Product change information (PCN)

PCN No.:	CAA180002	Date:	23.07.2018
Product:	MC 1,5/...-G(F)-3,81...THR...

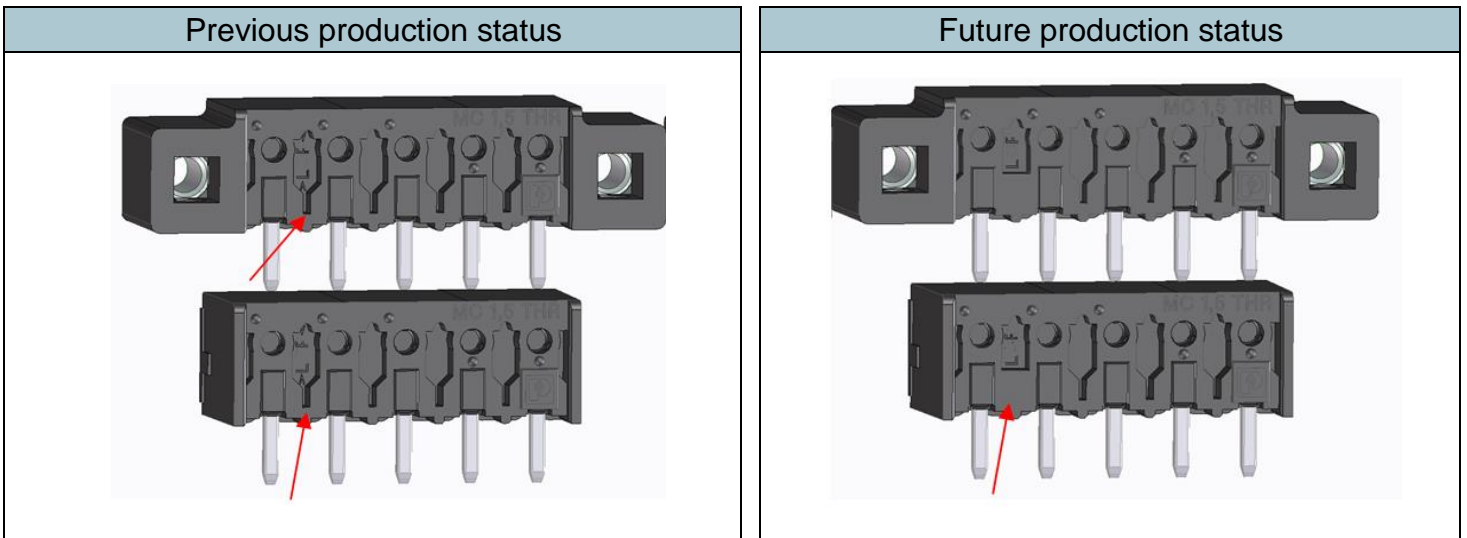
Reduction in size of one impression on the rear side

In order to optimize the production process, one of the impressions on the rear side of the housing will be reduced in size. The change can be found on the left-hand or right-hand side of the product. This change will not affect the external dimensions, PCB layout, or technical data. Depending on the amount of stock and the number of positions, both versions will be supplied in parallel during the changeover phase.
